V2_Drainage Report - Final_COMMENTS.pdf Markup Summary

Ascent Church

Final Drainage Report

PCD File No: PPR265

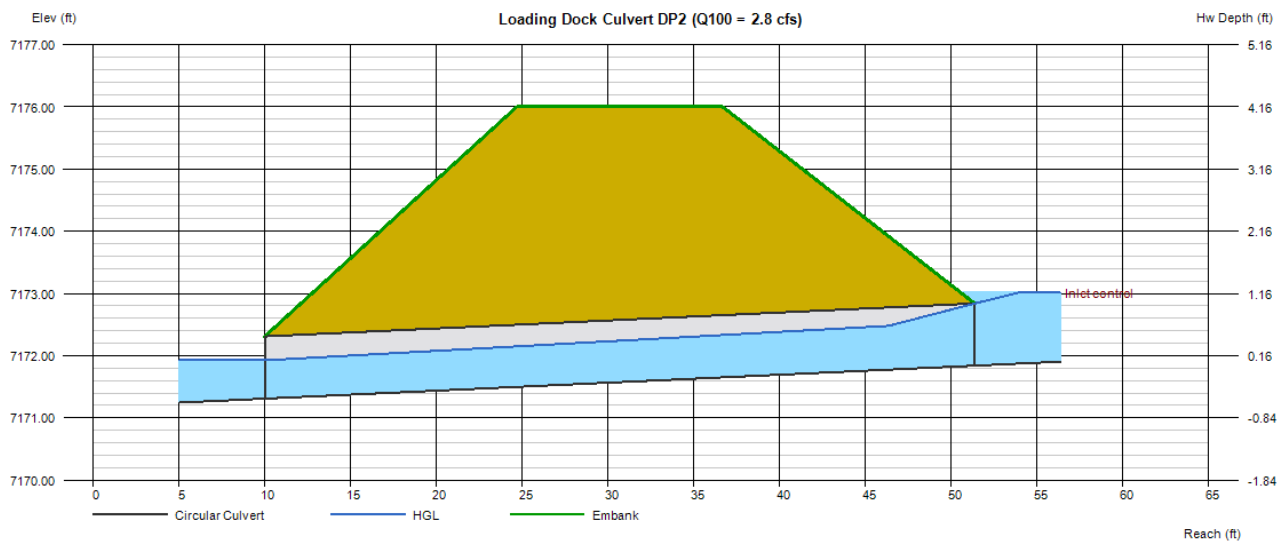
GEC Plan
missing
forebay

All Terrain: Not addressed. Developer has decided to not pursue CD approval at this time. The developer will continue to submit the documents for DP approval. Therefore, GEC plan will not be resubmitted.

DETENTION BASIN OUTLET STRUCTURE DESIGN

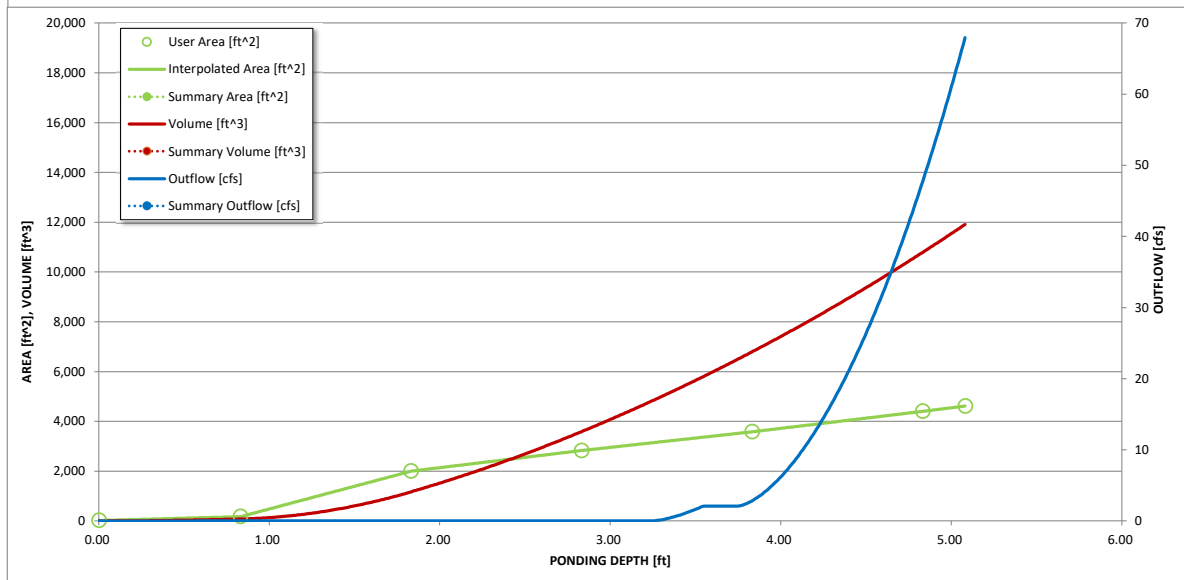
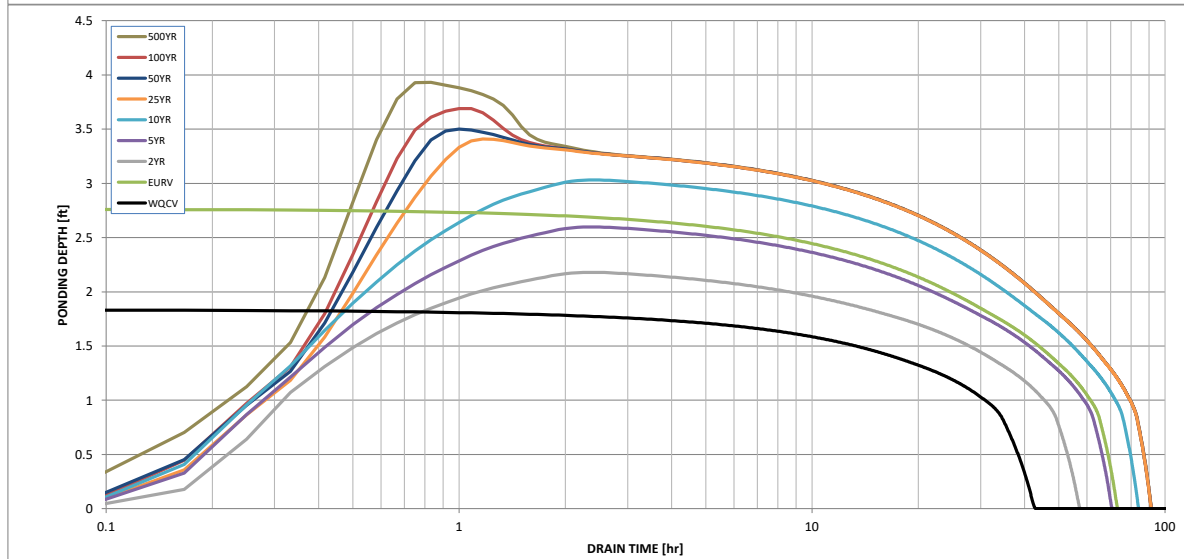
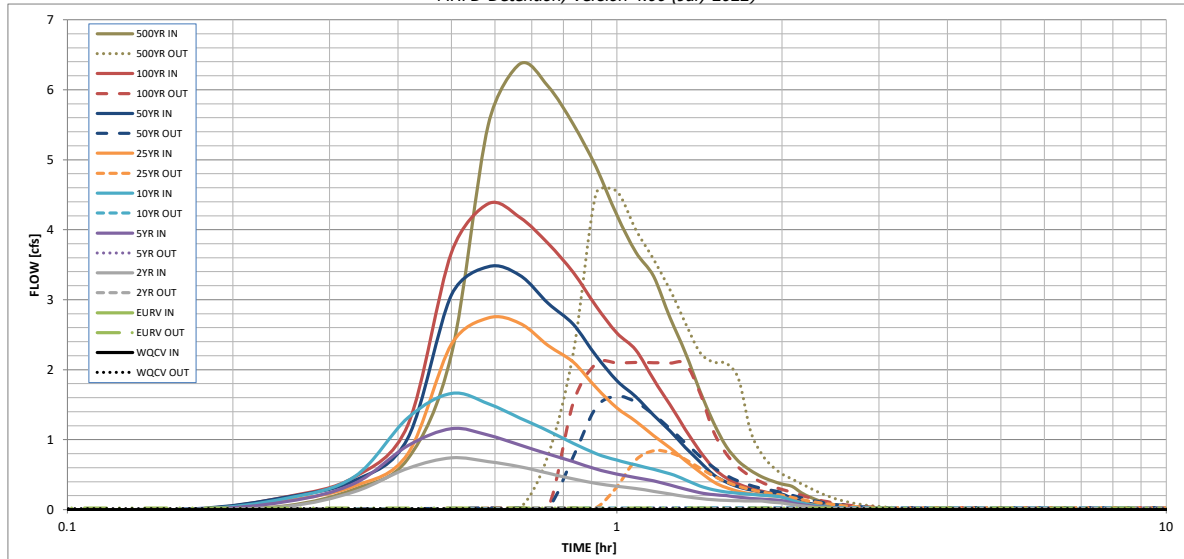
CDs show 3x3' grate

All Terrain: Not addressed. Developer has decided to not pursue CD approval at this time. The developer will continue to submit the documents for DP approval. Therefore, outlet structure details will not be resubmitted to address this comment. Grate should be 2' x 2'

PROPOSED DRAINAGE MAP

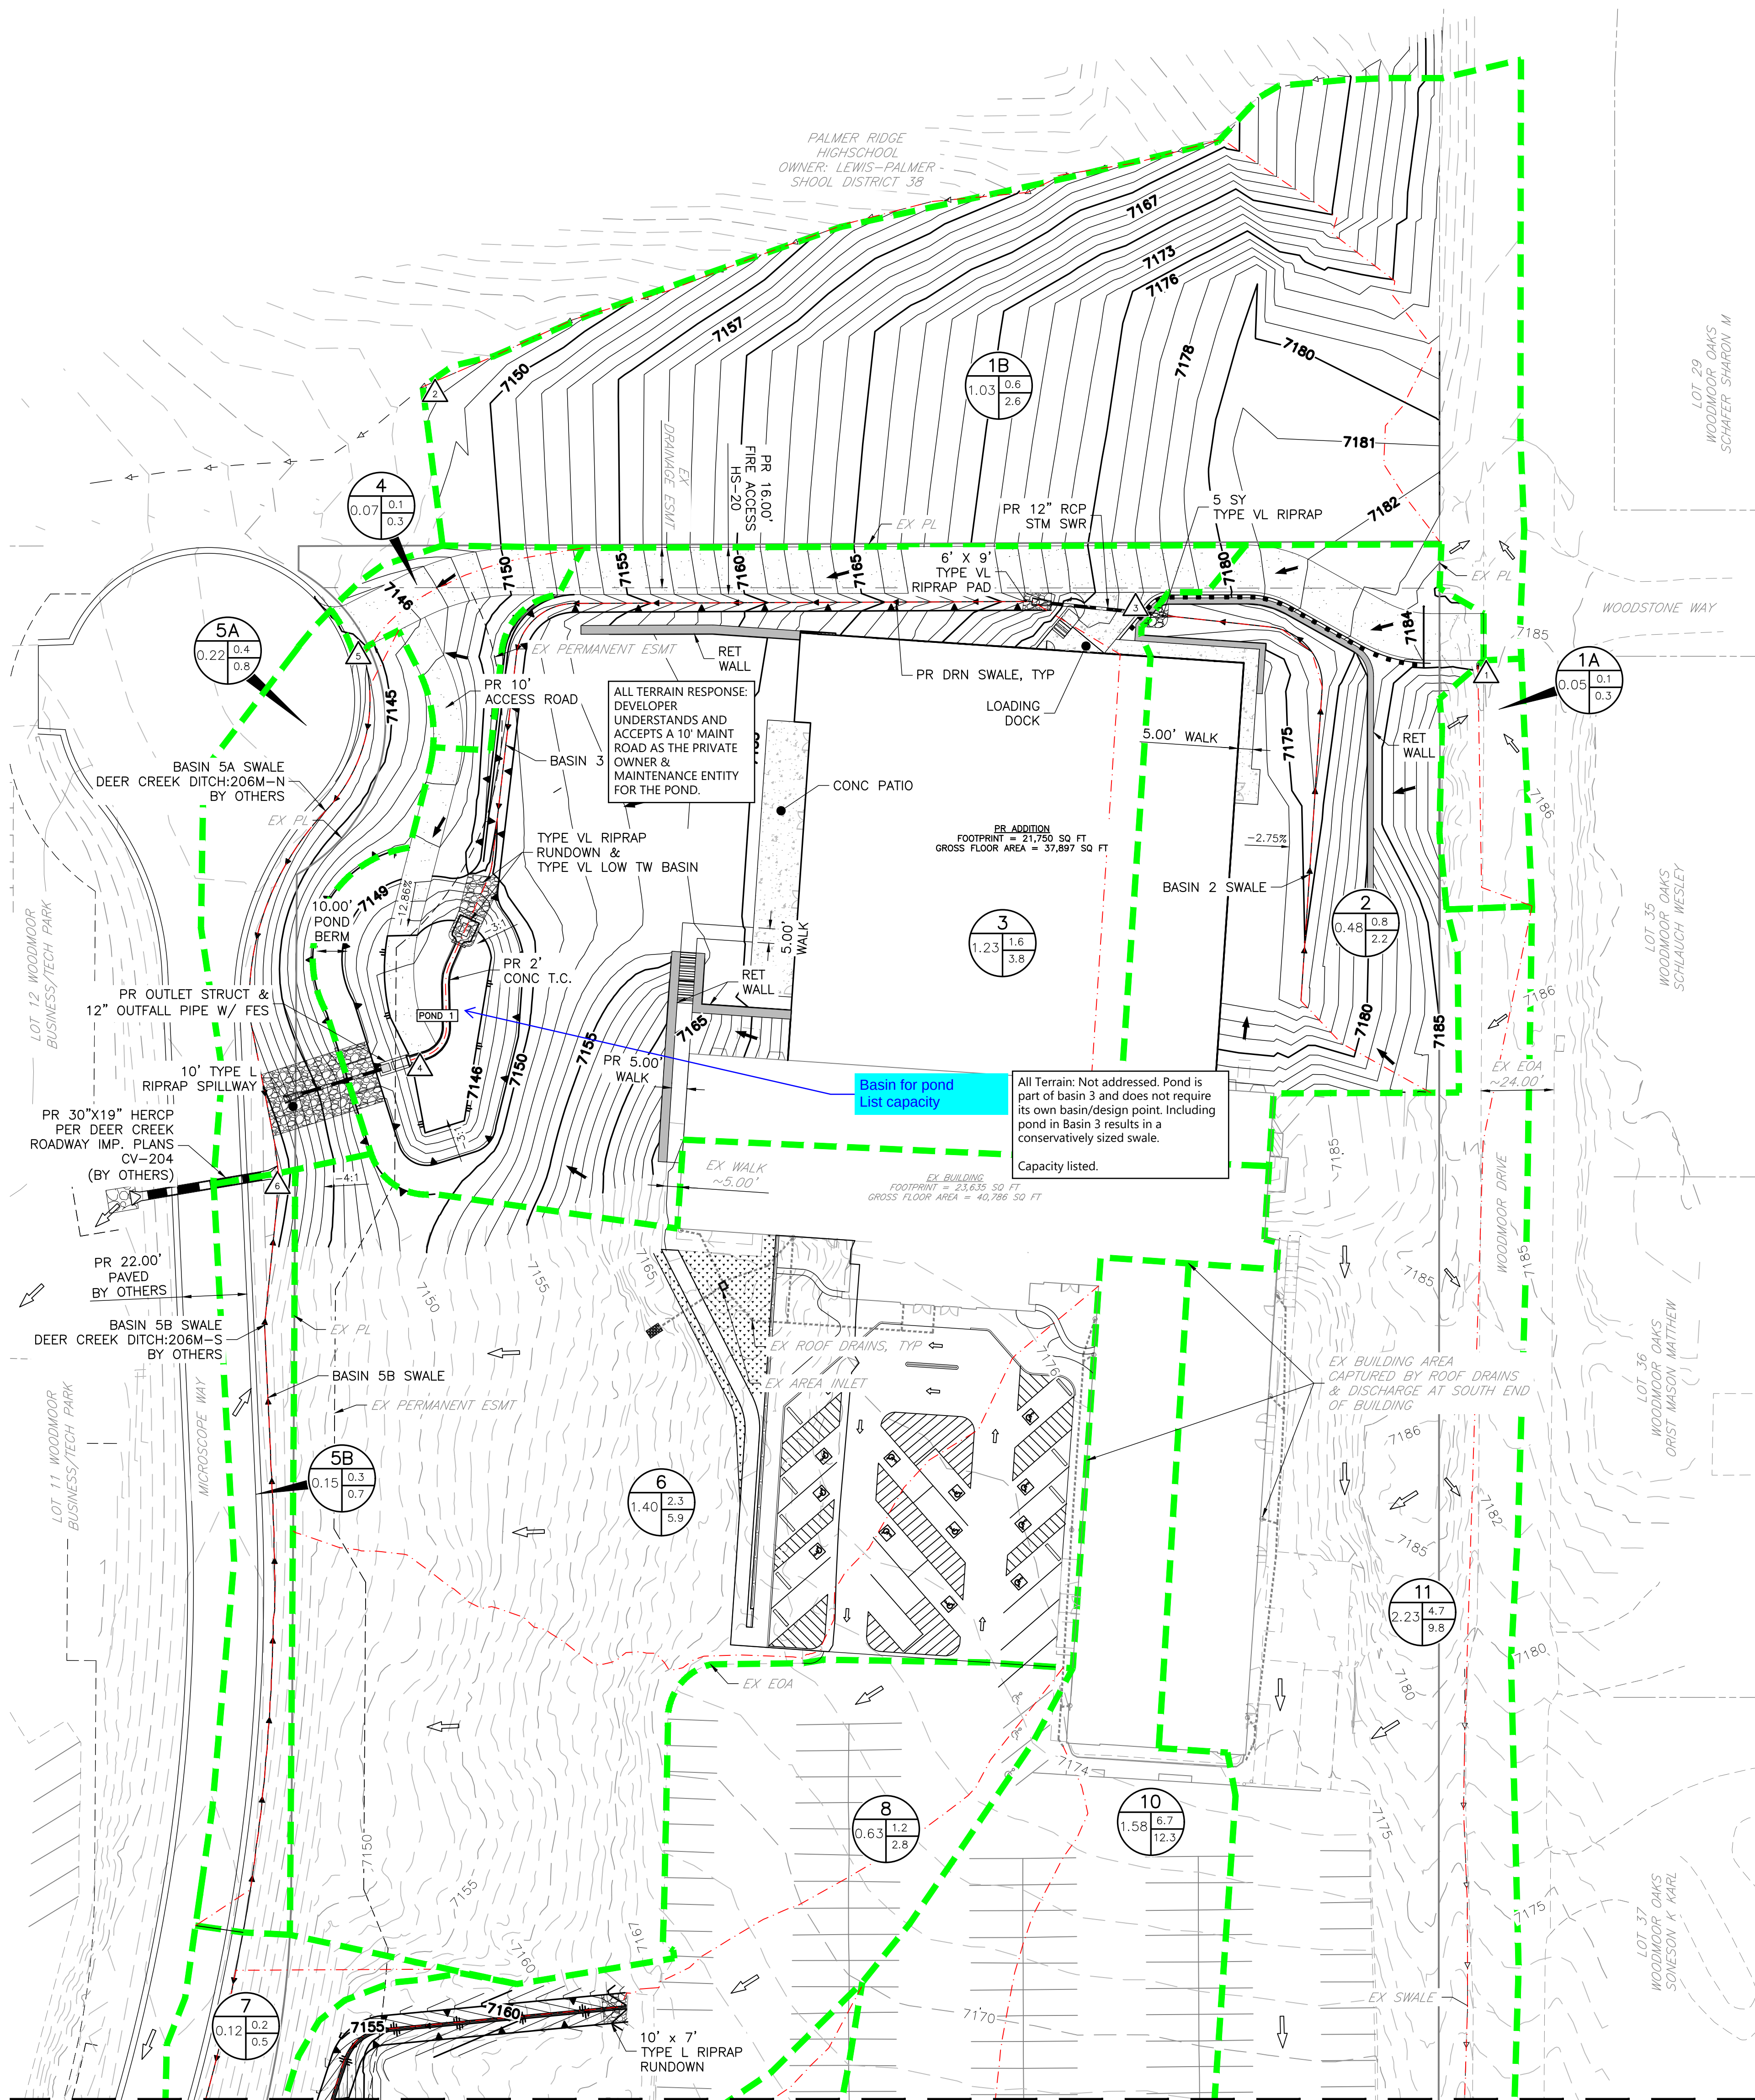
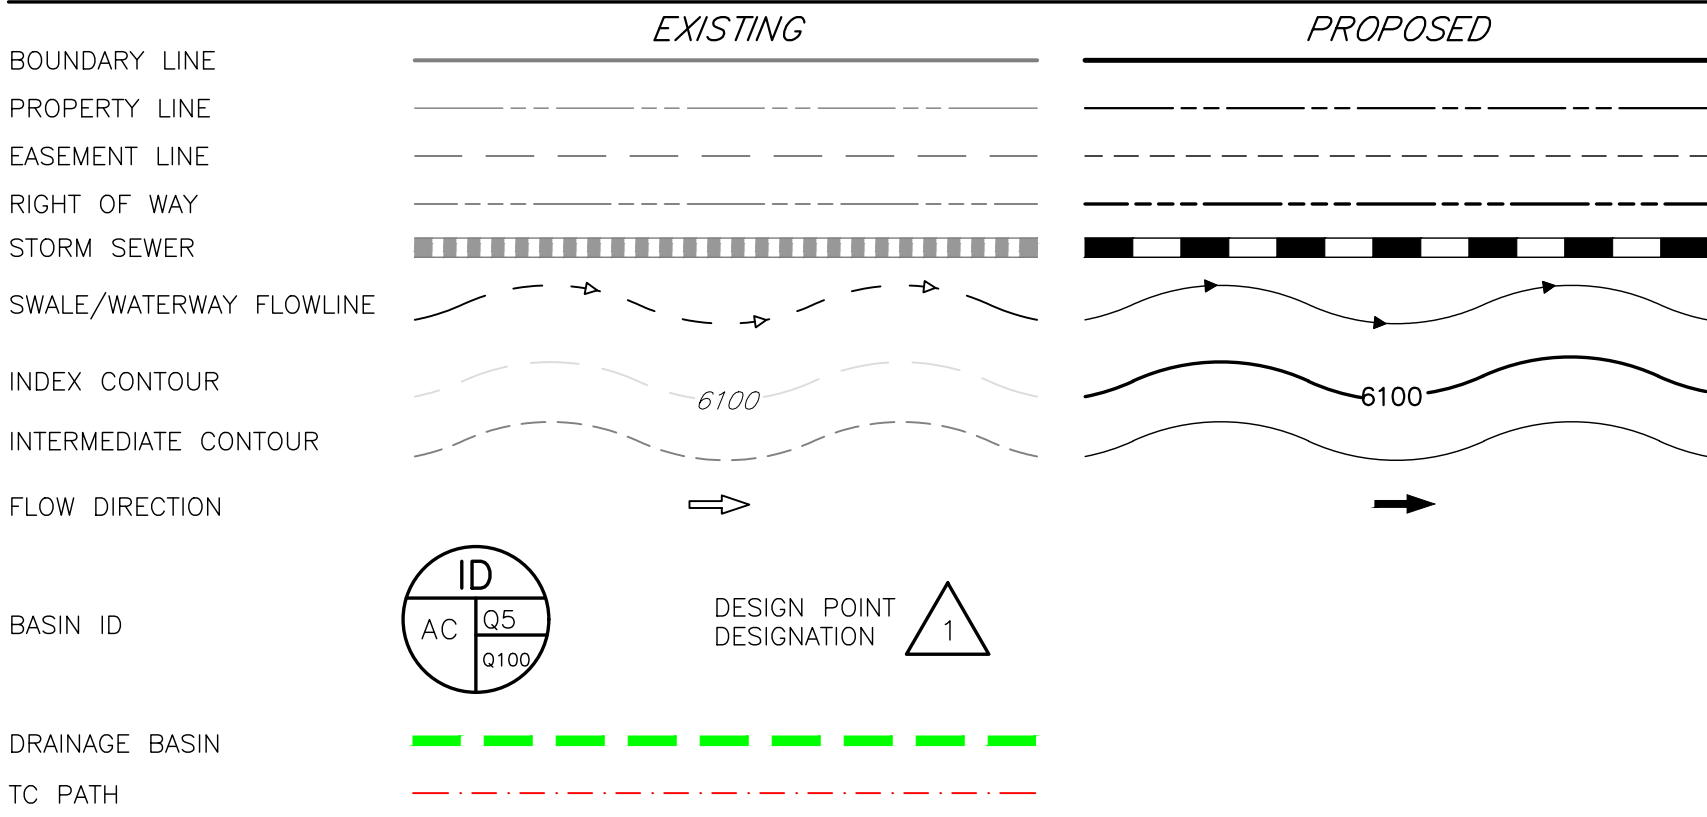
Subject: Callout
Page Label: [1] 25023_Pr Drainage Map-Pr Drain Map
Author: eschoenheit
Date: 5/14/2026 4:20:15 PM
Status:
Color: 
Layer:
Space:

Basin for pond
List capacity
